RE: WTC-C-21;
WTC-Dey Street,
Underpass; Borough of
Manhattan

In reply to your latest submittal of plans for the referenced project with a letter dated January 29, 1982, please be informed of the following comments of this Department:

Re: THE WORLD TRADE CENTER - Dey Street Underpass

SECTION G-G

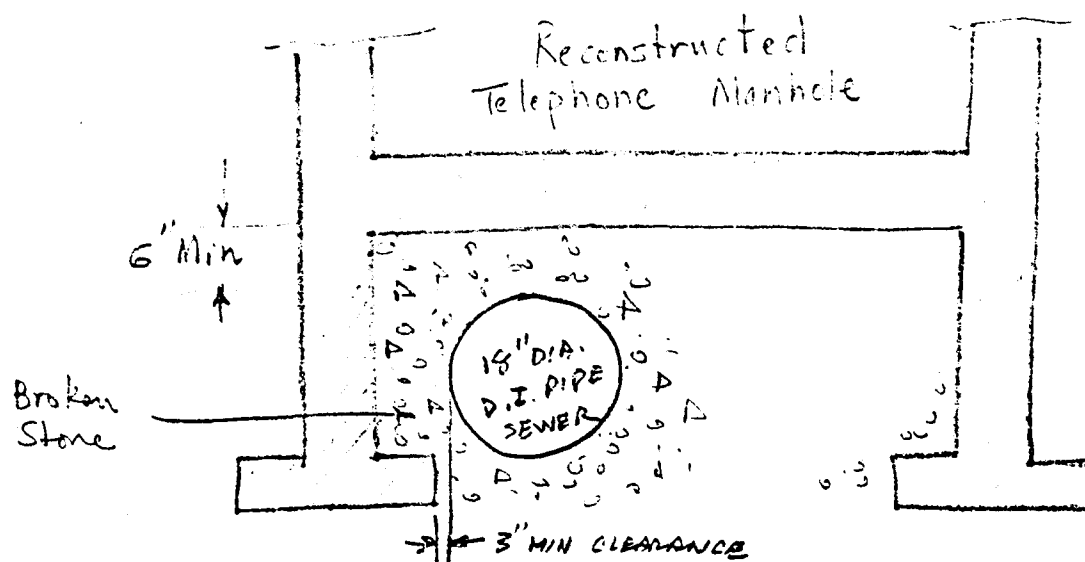
- 1) The load from the new reconstructed telephone manhole, located above the section of the proposed 18" Dia. D.I.P. sewer between manhole #2 and the existing manhole in Church Street, should be carried down to an elevation below the subgrade of the sewer, as shown in detailed section C-G. The east and west walls may be extended down and supported by continuous footings. Broken stone should be placed under and around the 18" Dia. D.I. sewer.
- 2) The section of proposed sewer between manholes #2 and 3 should be located so that its centerline is 2'-1" from the north building line of Dey Street. This same centerline clearance should be provided between the sewer and the C.D. of the 28" Dia. steam main casing.
- 3) Before final approval can be given for these plans, the details of the non-standard manholes and any other special sewer structures must be received for our review.
